ADDENDUM #1
INVITATION FOR BID #22-33

POLICE HEADQUARTERS HVAC SYSTEM IMPROVEMENTS

THIS ADDENDUM IS TO: ANSWER THE QUESTIONS BELOW AND TO PROVIDE AMENDED PROJECT DRAWINGS, ATTACHED:

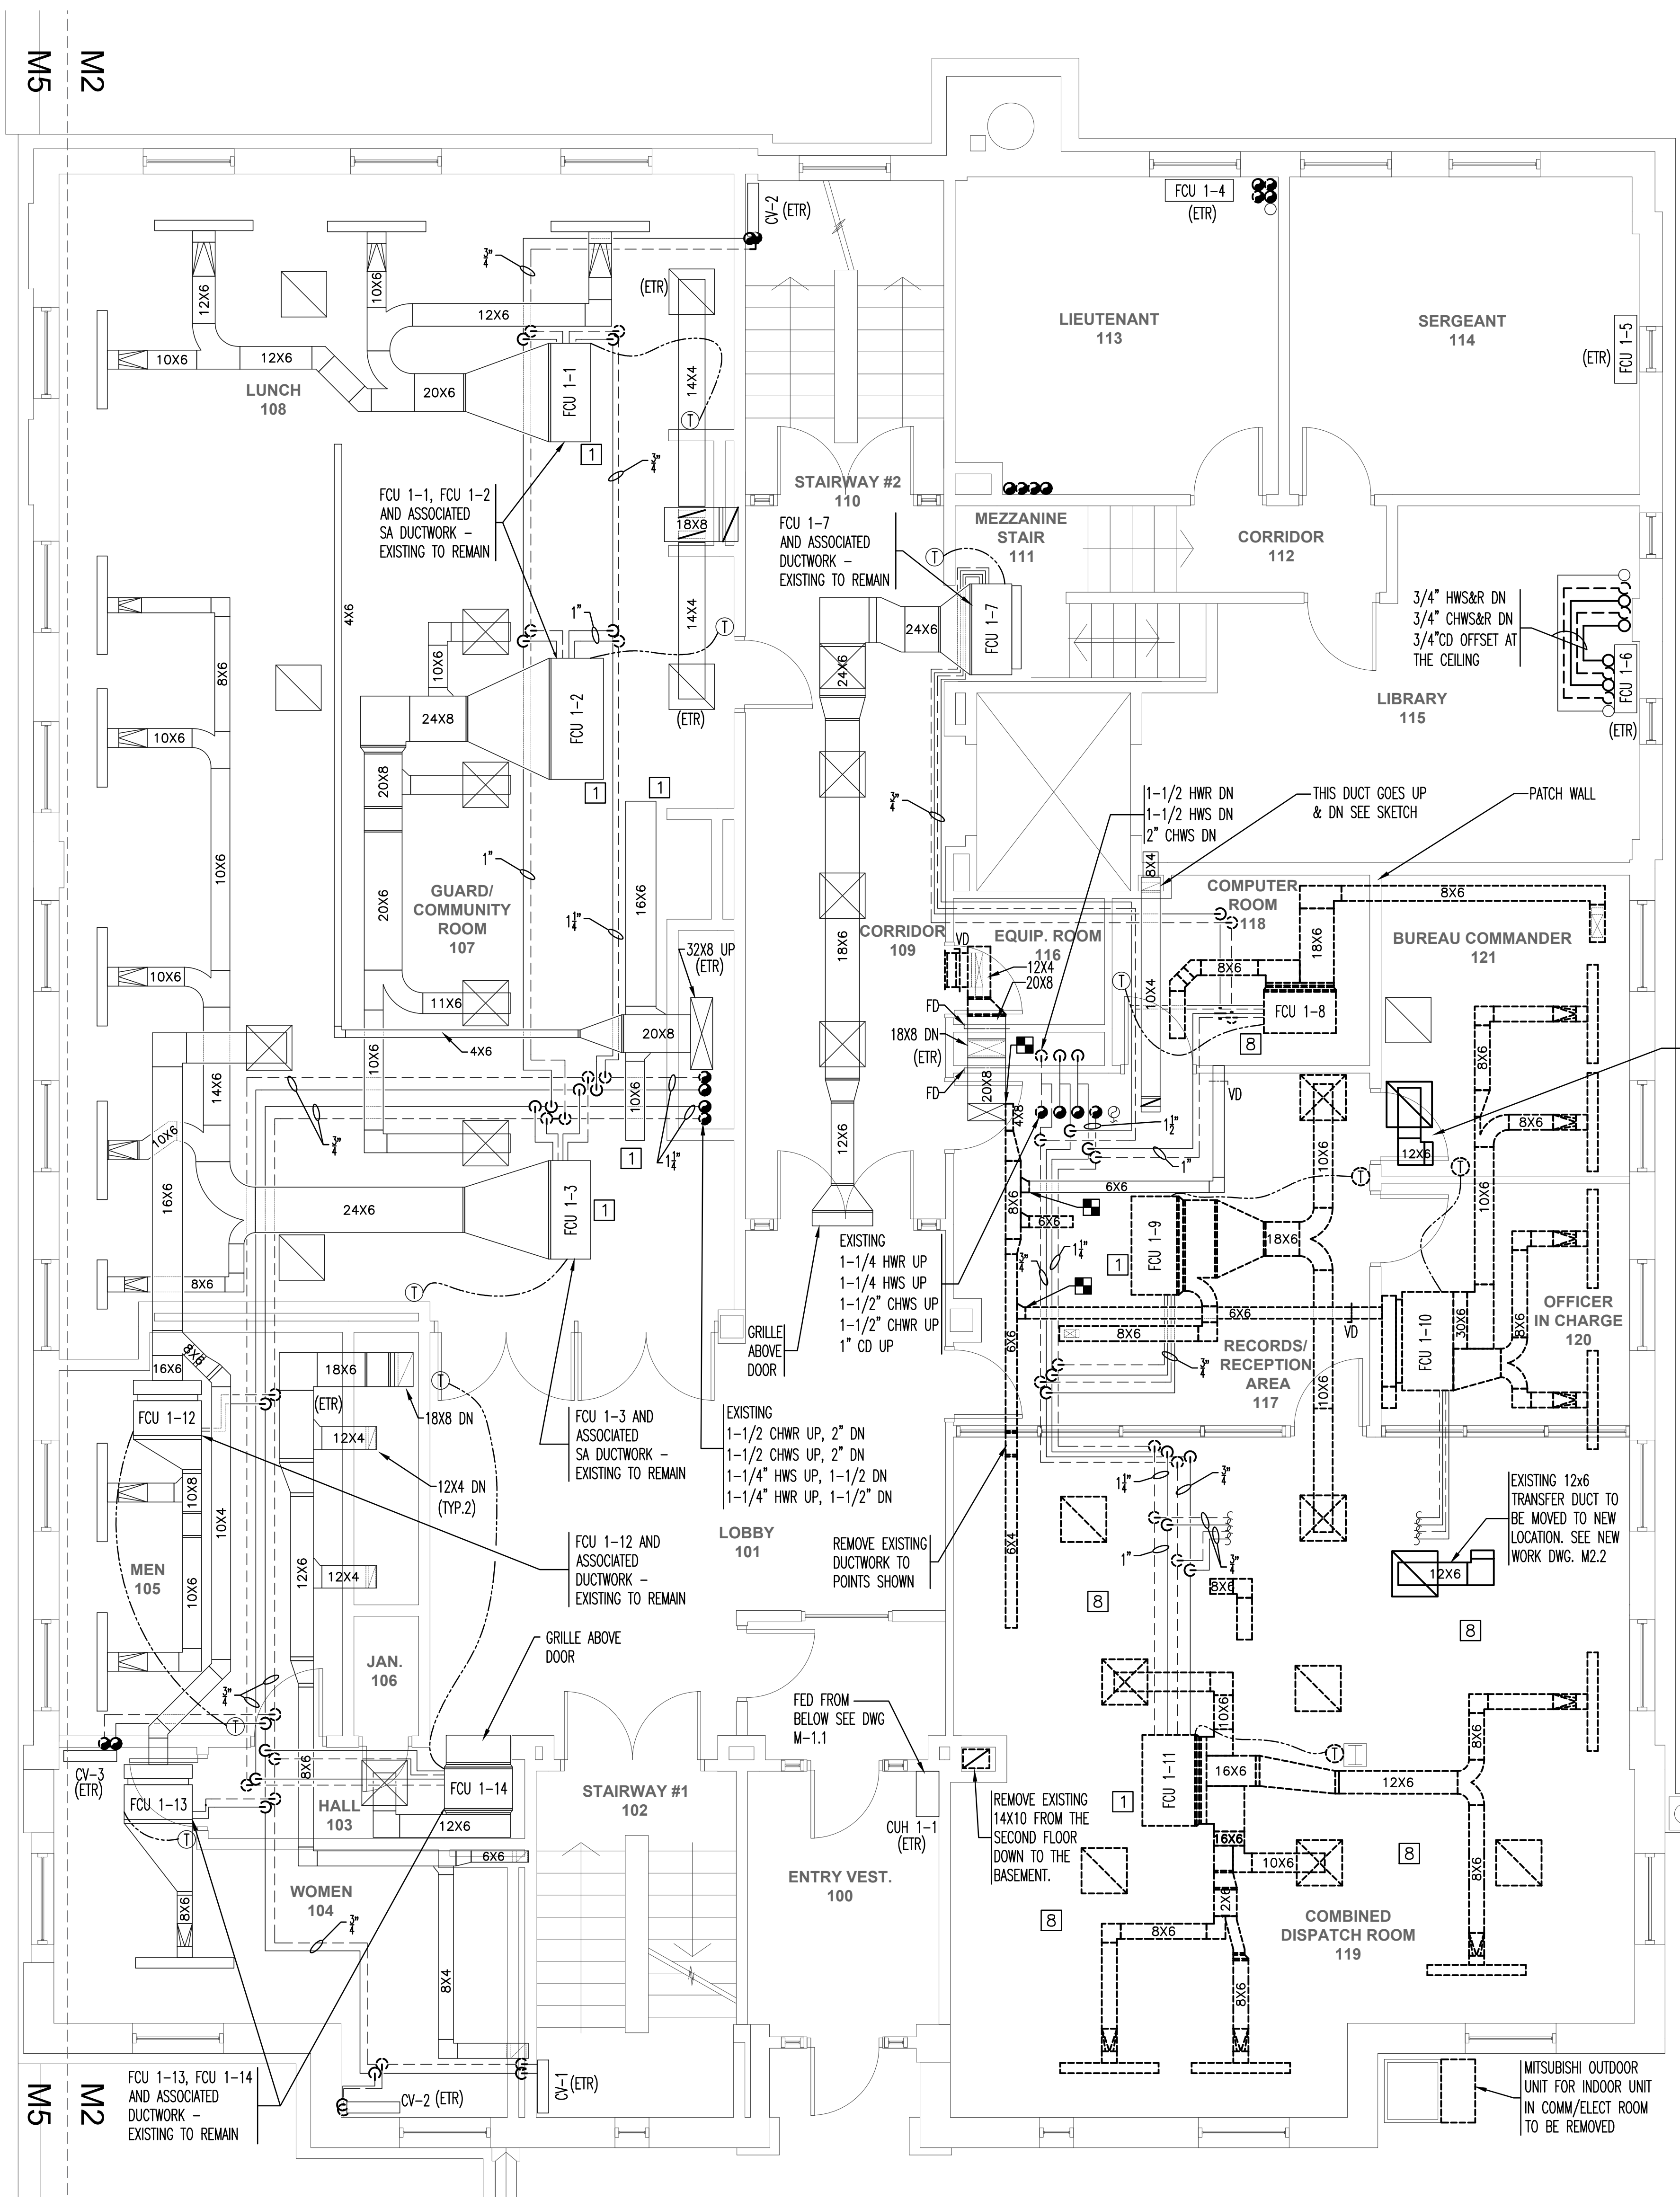
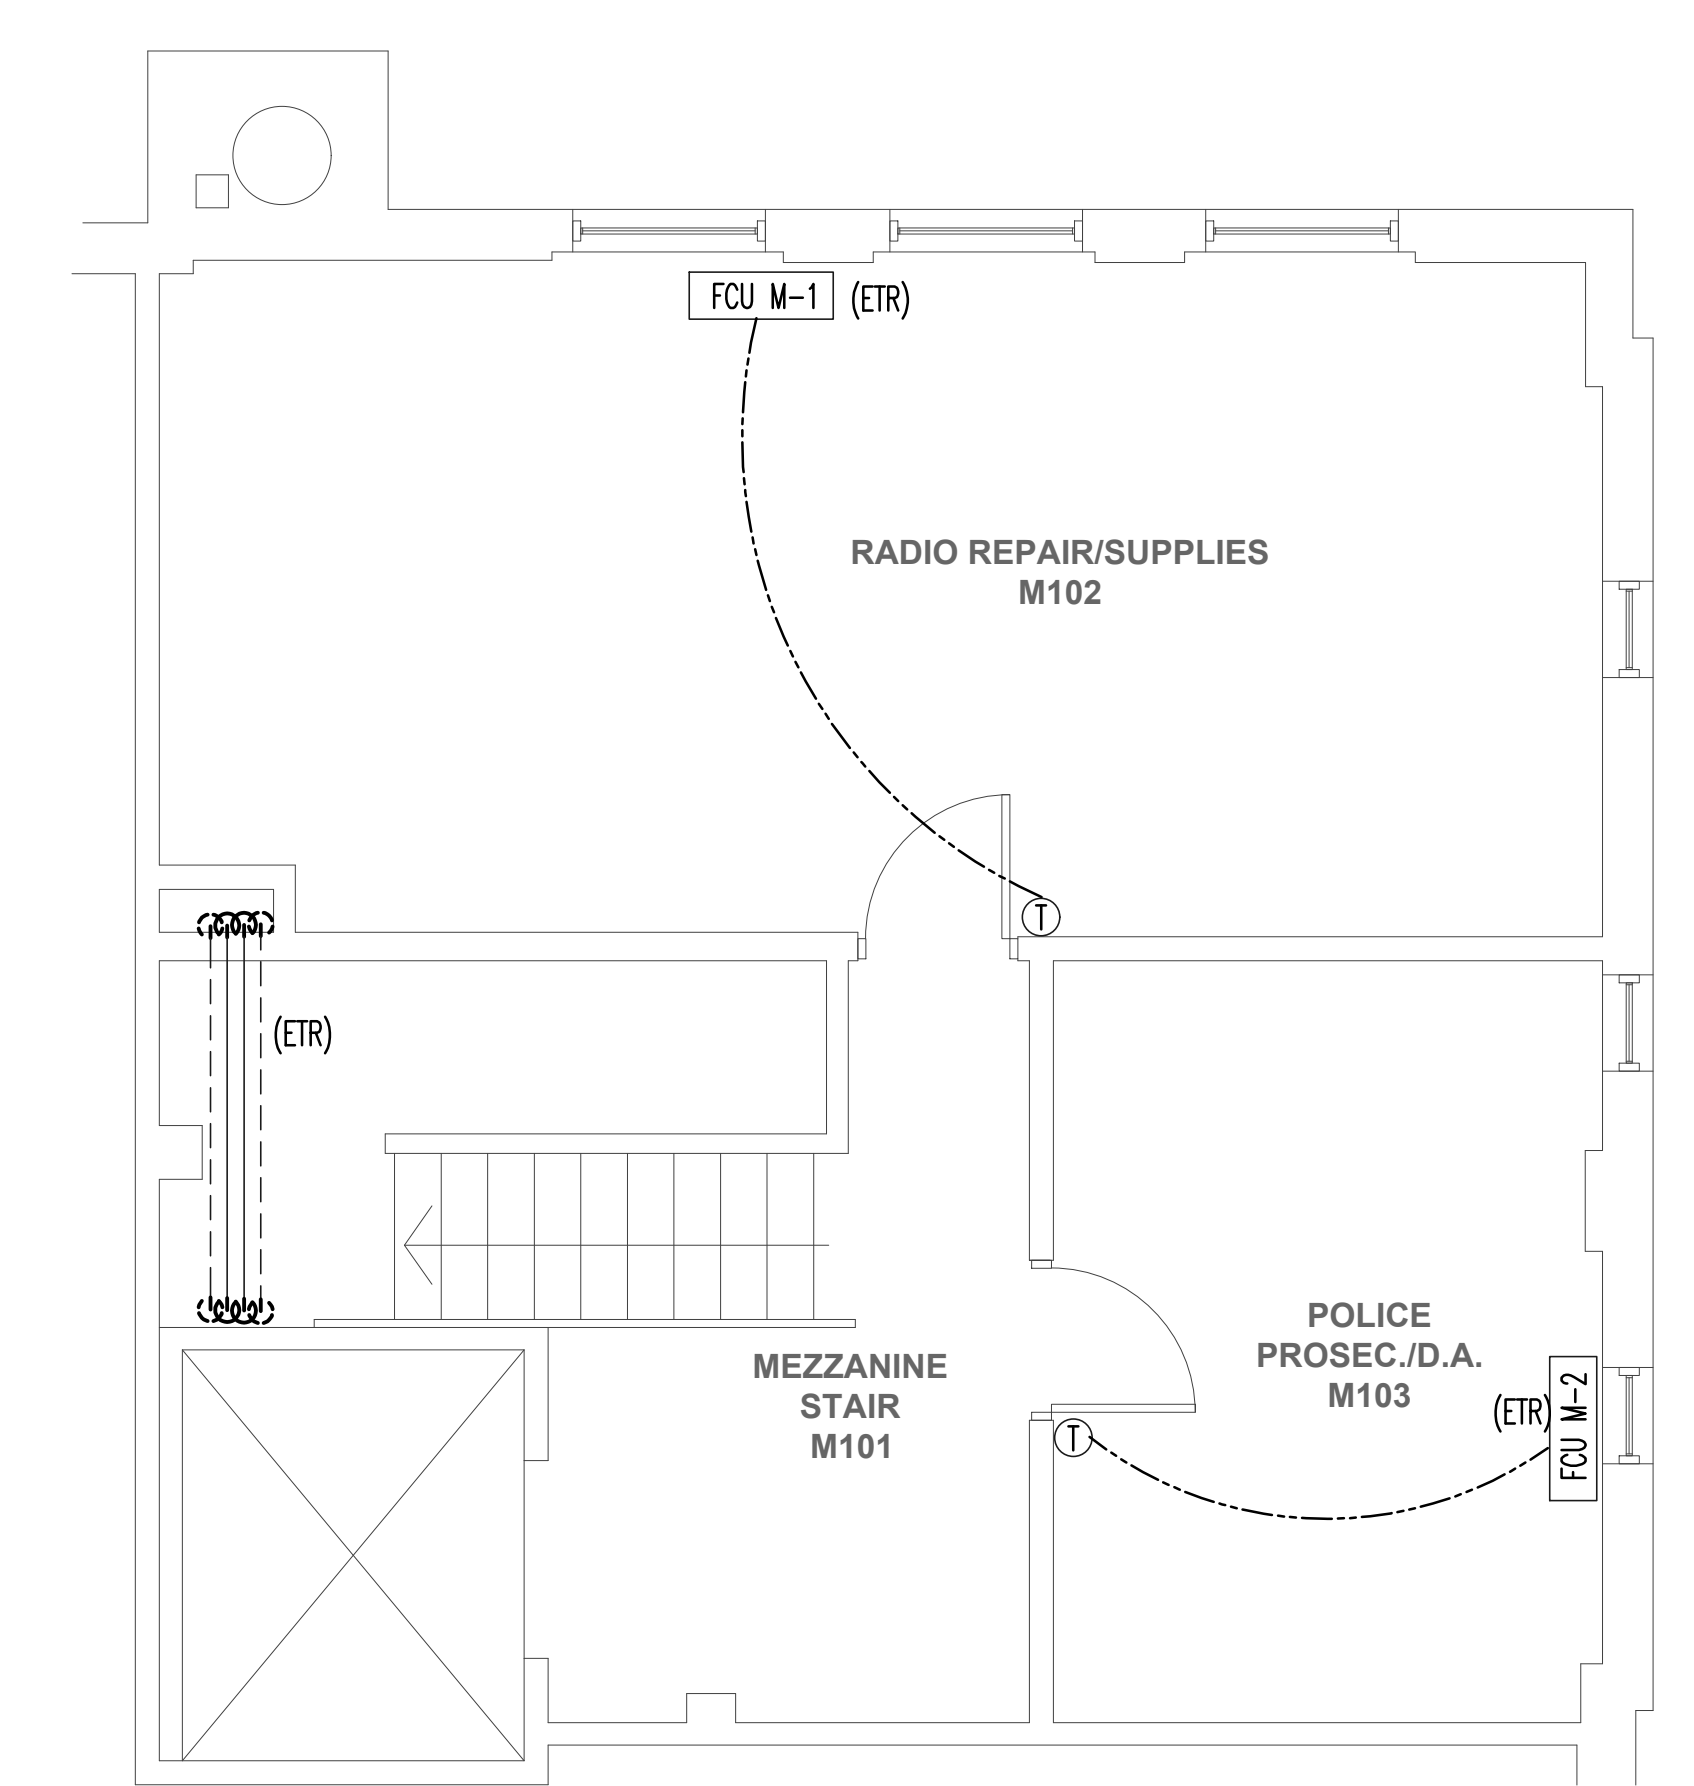
Q4. Keynote 1A on Drawing M-1.1 and M-2.1 indicate the replacement of the control valves at the existing FCU's are to be included in Alternate #1 yet none of the FCU's are tagged with this keynote. Keynote 2 on Drawings M-1.2, M-2.2 and M-3.2 appears to indicate the replacement of the control valves at the existing FCU's would be in the base bid as no alternate is referenced. Please review and provide clarification.

Drawing M-1.1: Keynoted 1A was converted to a General Note clarify what portion of the work the control valves and dampers were to be priced.

A4. The Keynotes on Drawings M-1.1 and M-2.1 have been updated to reflect that the valve work will be included in the Base Bid.

- GENERAL NOTE FOR SHEET: THIS WORK WILL INCLUDE REMOVING AND REPLACEMENT OF THE EXISTING CONTROL VALVES FOR THE HOT AND CHILLED WATER COILS OF THE FAN COILS THAT ARE GOING TO BE REPLACED UNDER THIS ADD ALTERNATE. THE EXISTING VALVES ARE SHOWN AS BEING PNEUMATIC THREE-WAY VALVES. THE VALVES SHALL BE REMOVED AND THE PNEUMATIC TUBE CUT BACK AT THE MAIN AND PERMANENTLY CAPPED.

1 SECOND FLOOR HVAC DEMOLITION PLAN
SCALE: 1/4" = 1'-0"

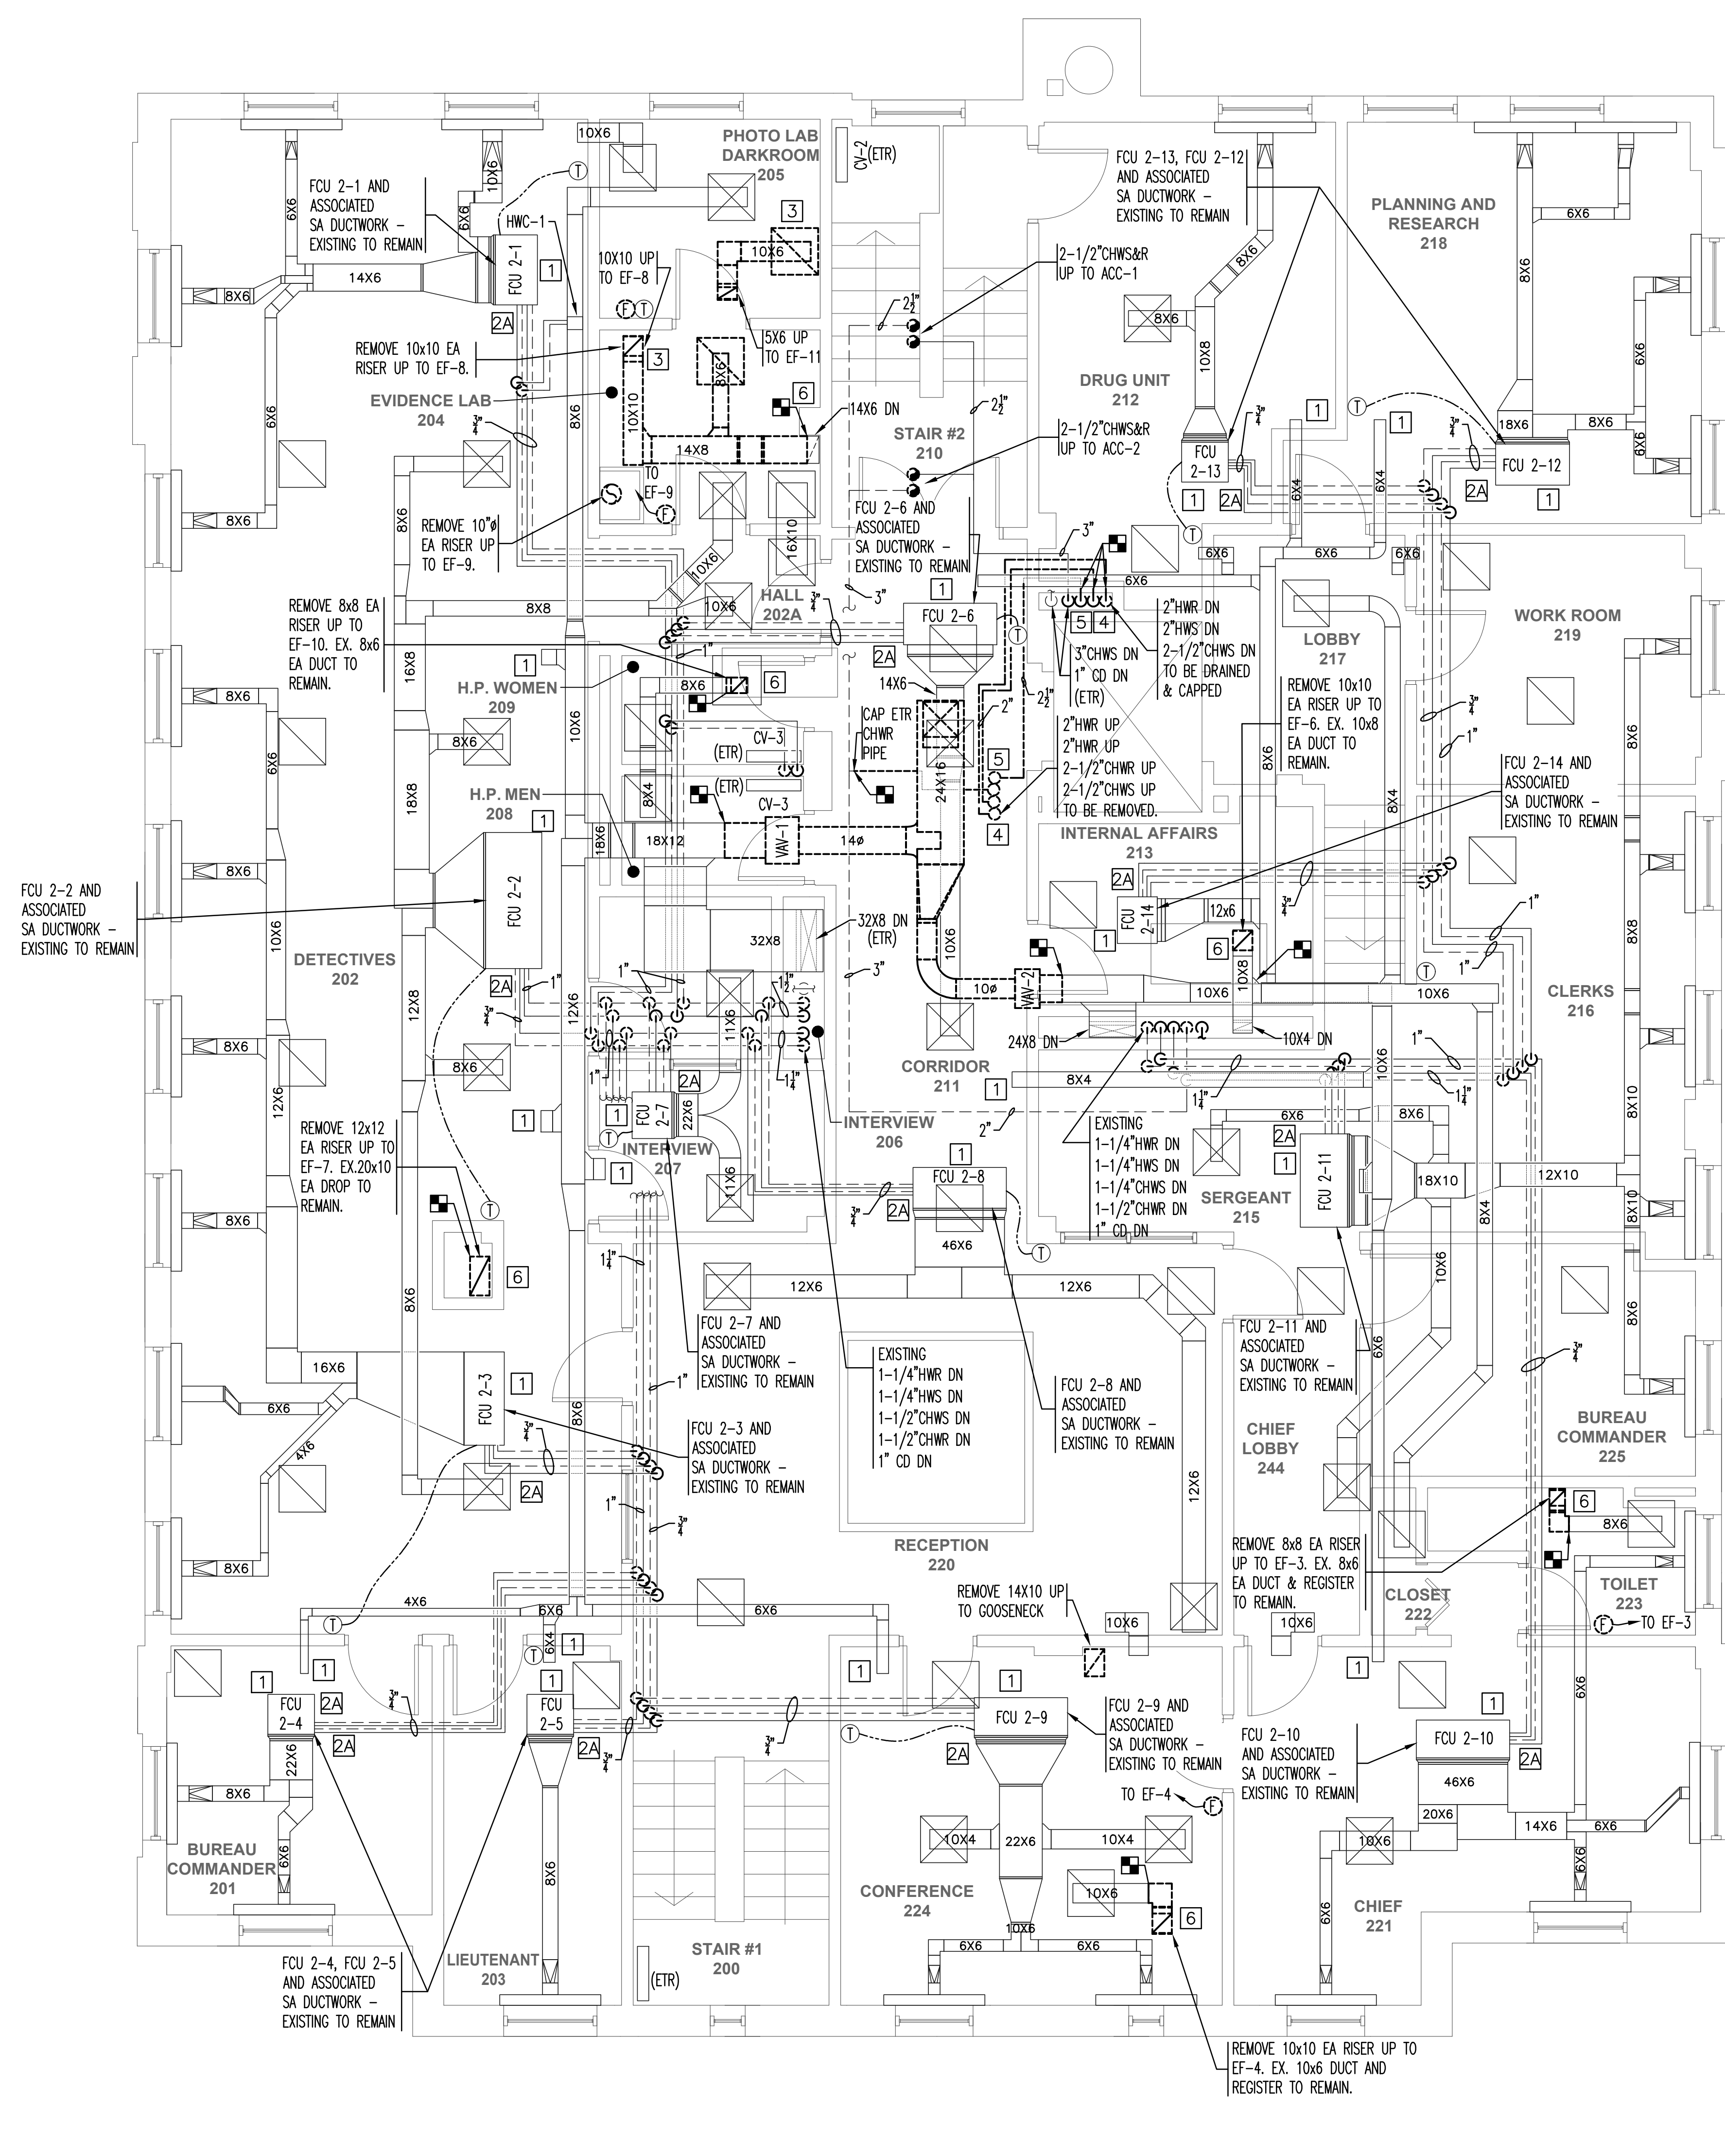
Q5. Keynote 2A and 2B on Drawing M-3.1 appear to reference the wrong alternate. Alternate #2 is work associated with the firing range upgrades. Please review and provide clarification.

Drawing M-2.1: Converted the Note about valves to a General Note and removed the reference to Alternate #1.

A5. The Keynotes on M-3.1 have been updated to reflect that the Alternate should be #1 for the DDC Head End. Please note that the valve work is part of the Base Bid

2A BASE BID WORK: THE EXISTING CONTROL VALVES FOR THE HOT AND CHILLED WATER COILS OF THE FAN COILS ARE GOING TO BE REPLACED UNDER THIS ADD ALTERNATE. THE EXISTING VALVES ARE SHOWN AS BEING PNEUMATIC THREE-WAY VALVES. THE VALVES SHALL BE REMOVED AND THE PNEUMATIC TUBE CUT BACK AT THE MAIN AND PERMANENTLY CAPPED.

1B (ADD ALTERNATE #) WHEN ALL OF THE PNEUMATIC CONTROLS HAVE BEEN REMOVED FROM THE BUILDING AND THERE ARE NO OTHER USES OF COMPRESSED AIR THEN HAVE THE ELECTRICIAN MAKE THE COMPRESSOR SAFE FOR REMOVAL AND TURN OVER TO THE OWNER.
